From: Scala, Mary Joy
Sent: Monday, February 27, 2017 11:18 AM
To: Mollica, Mike; Bill Mechnick (Bill@lpda.net)
Subject: BAR Action - 800 E Market Street - February 22, 2017

RE: Certificate of Appropriateness Application
BAR 16-03-02
800 East Market Street
Tax Parcel 530160000
City of Charlottesville, Owner/Facilities Dev./Public Works Dept., Applicant
Landscape Plan

**CITY OF CHARLOTTESVILLE
BOARD OF ARCHITECTURAL REVIEW
STAFF REPORT
February 22, 2017**

Landscape Plan

Drawing Title
**Layout, Grading,
 Site Improvements,
 Planting**

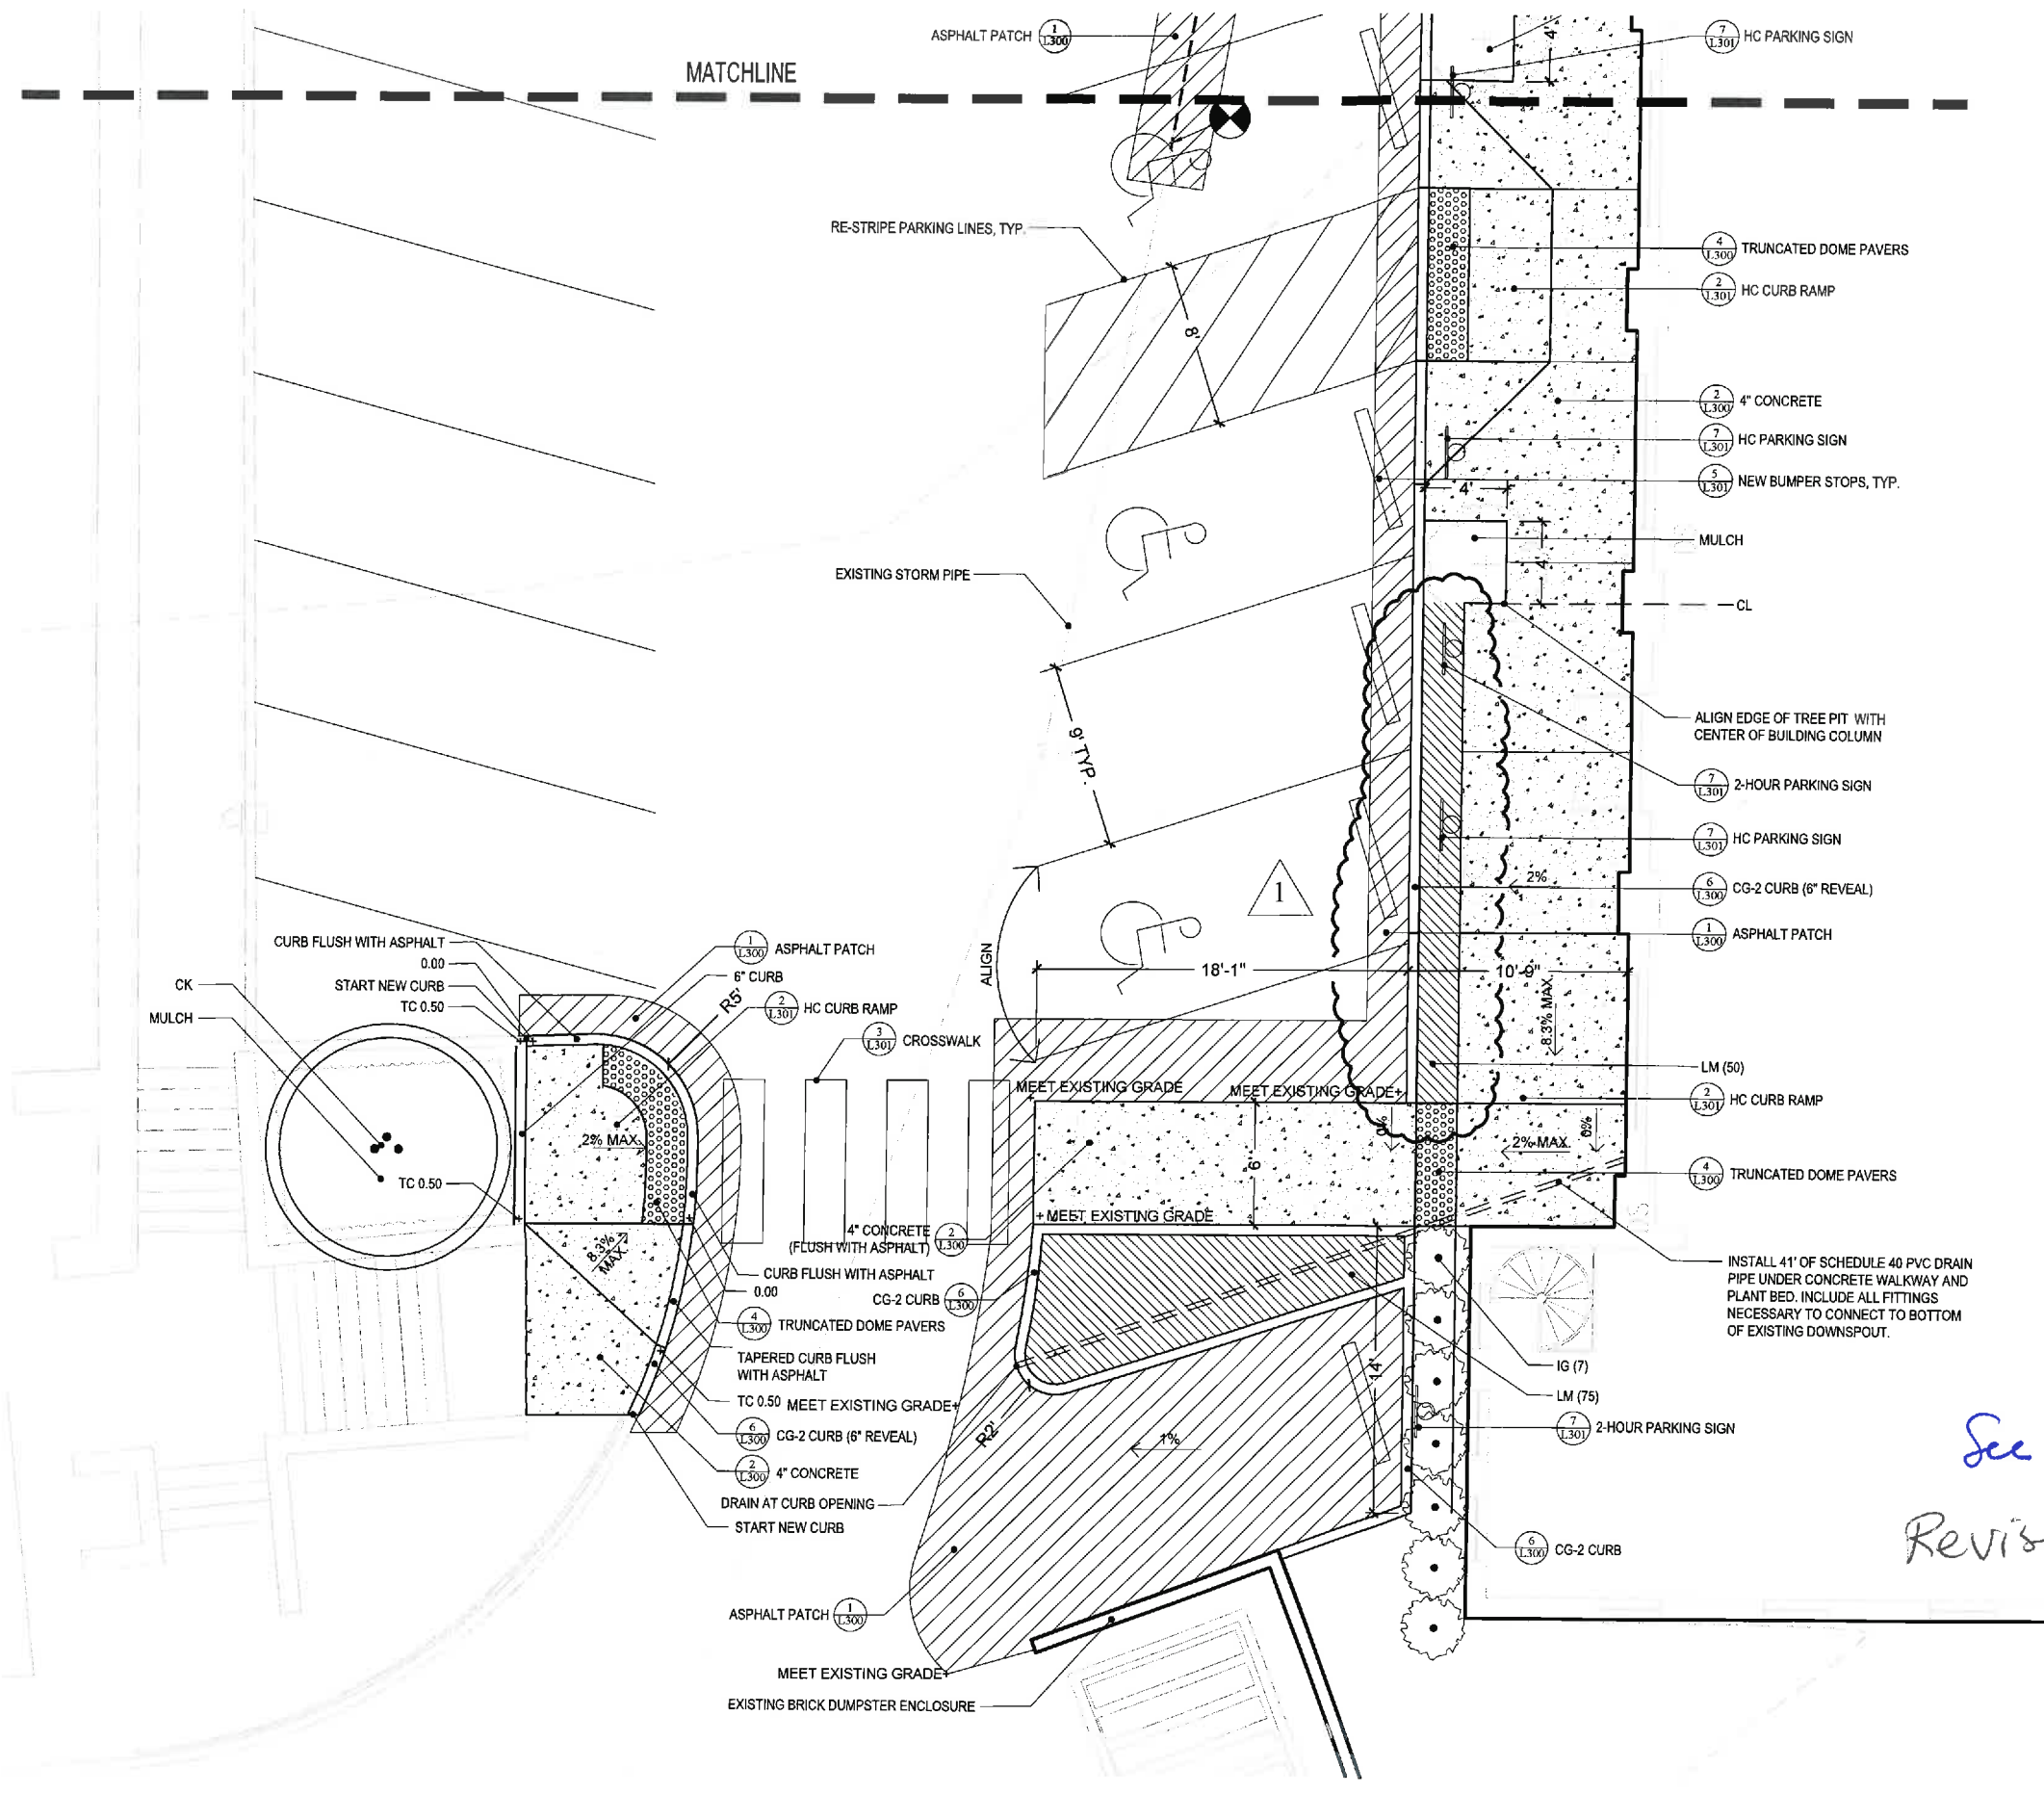
No.	Revision	Date
1	Field change - grade at rear door	02-15-17

Drawing Title
**Layout, Grading,
 Site Improvements,
 Planting**

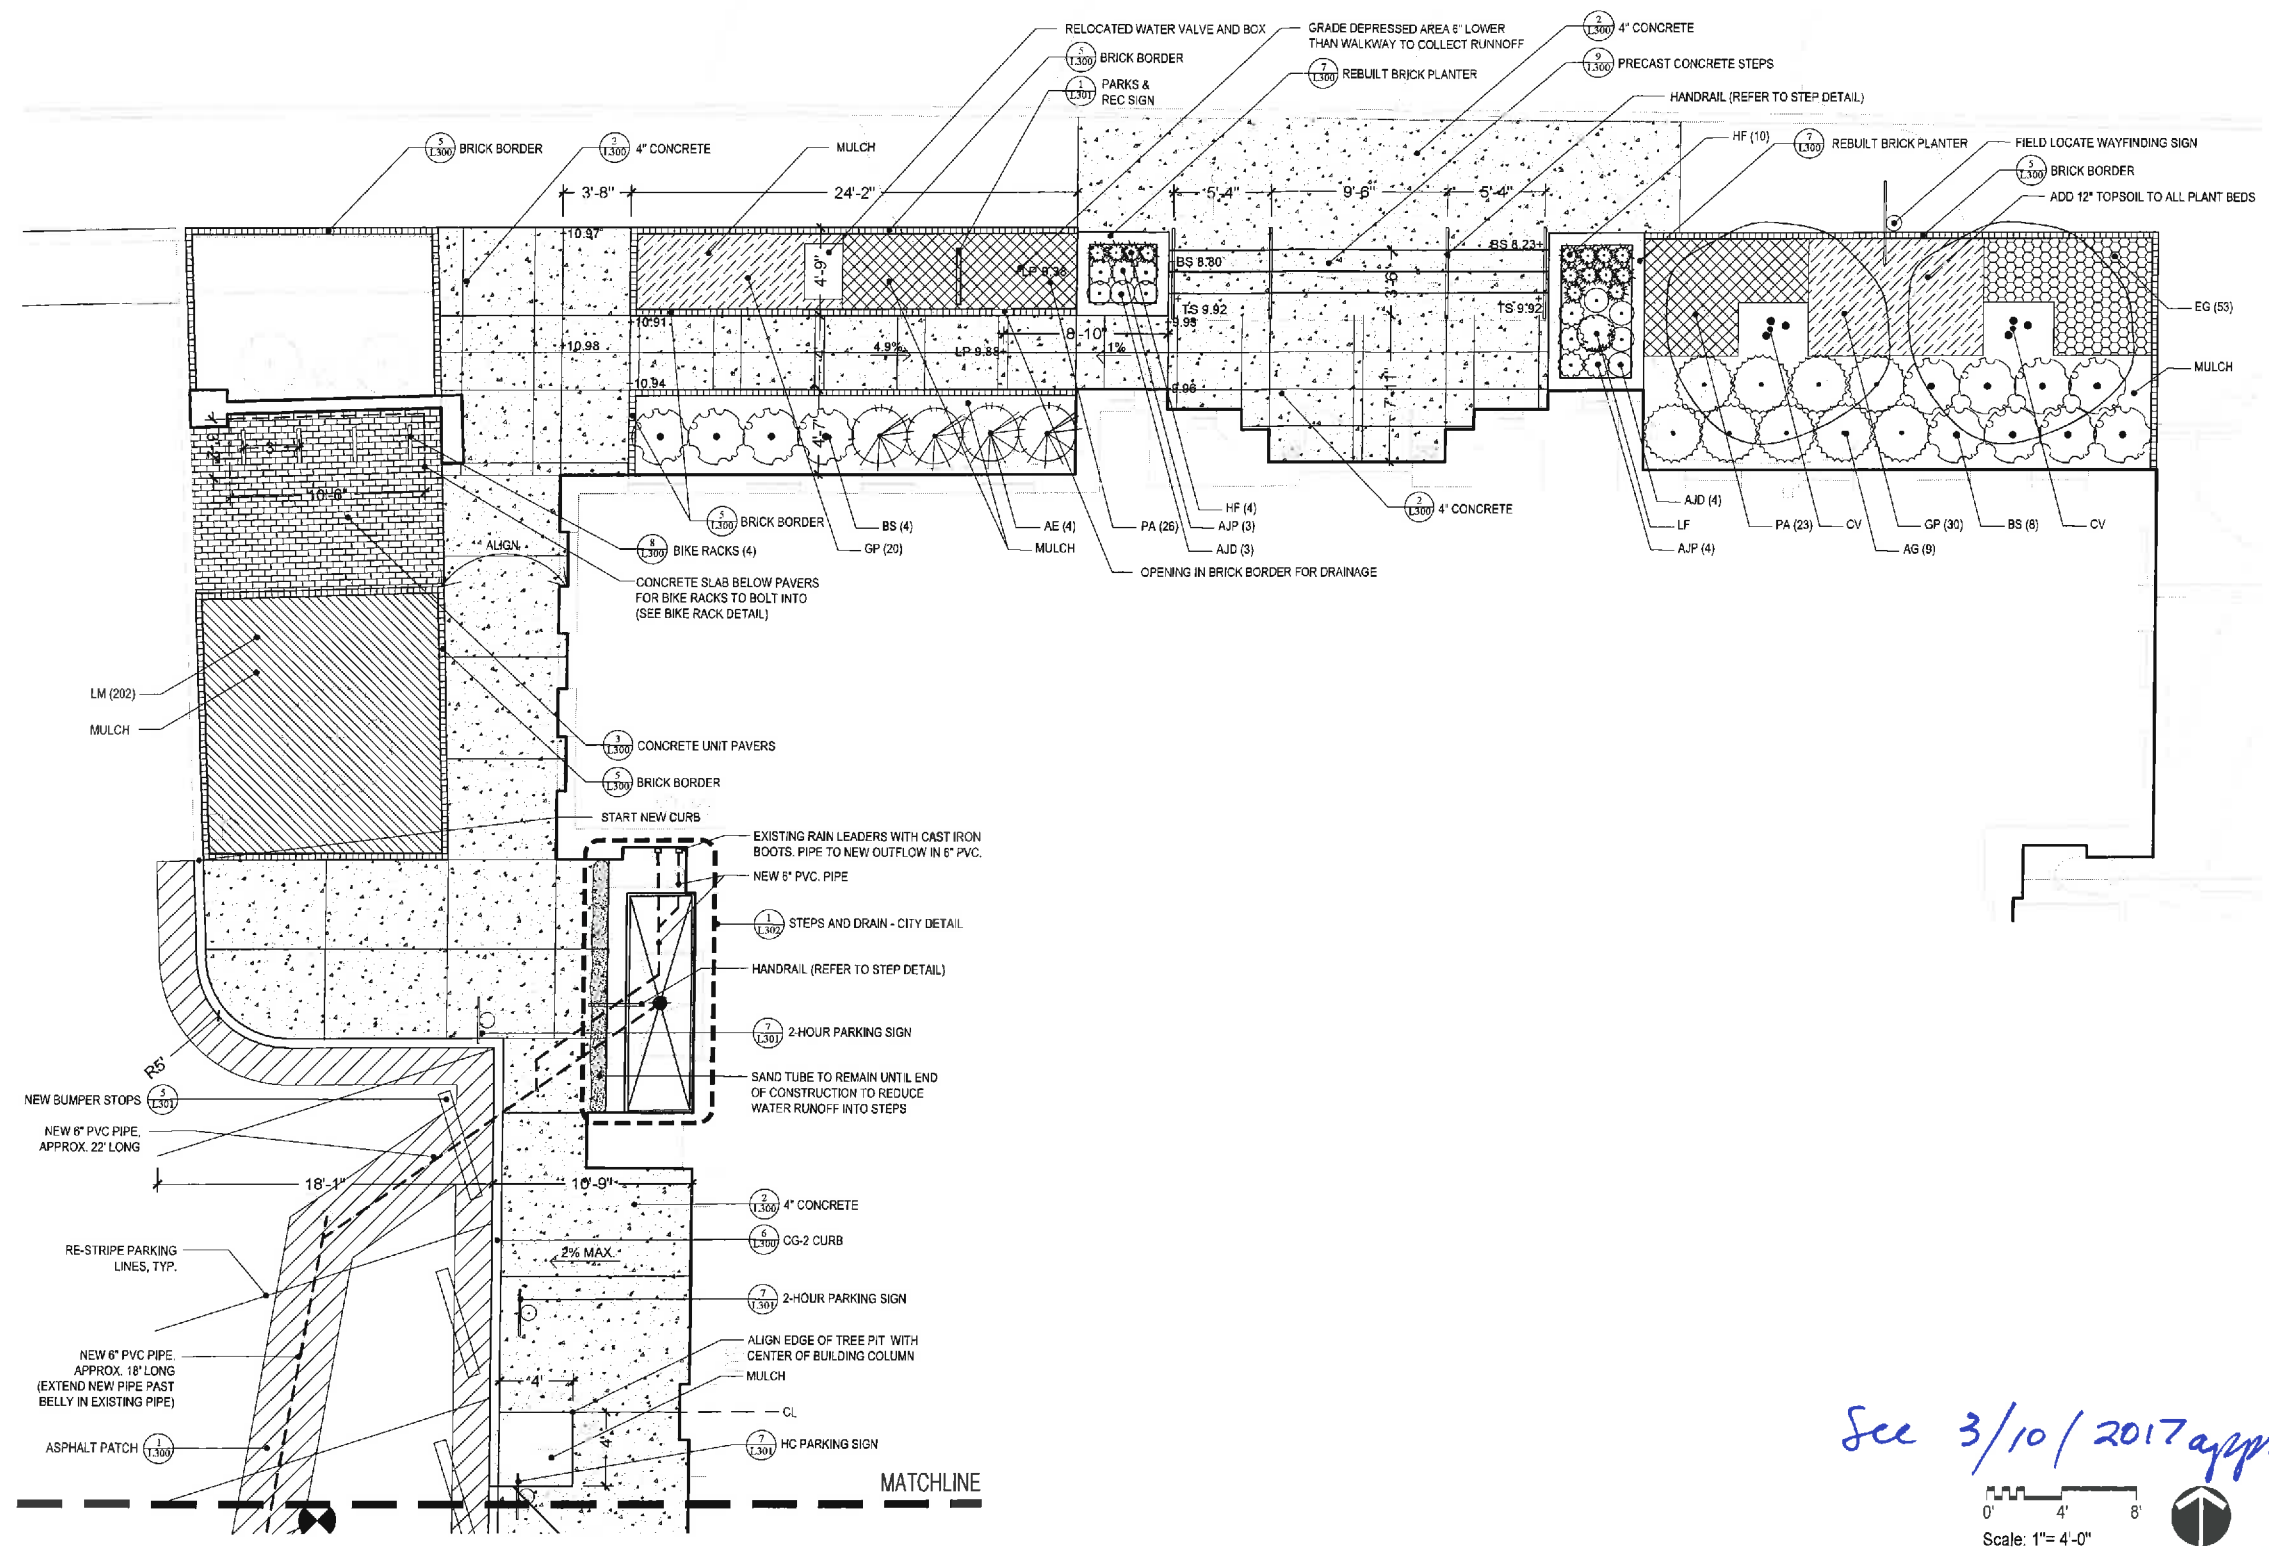
The January submittal was revised slightly to add a 2' planted strip with liriop on the west side to assist in meeting ADA grades.

- Pennsylvania Sedge and American Maidenhair Fern groundcovers replaced with Big Blue Liriope, Bishop's Hat, Creeping Wintergreen, and Christmas Fern.
-
- Replace one Redbud with two White Fringetree;
- In front stair planters replace Creeping Phlox and Soft Touch Holly with Hosta and Astilbe perennials, and Leucothoe evergreen shrub.
- Replace Green Lustre Holly Hedge near building front with Variegated Boxwood, White Azalea and Autumn Twist (variegated pink) Azalea.
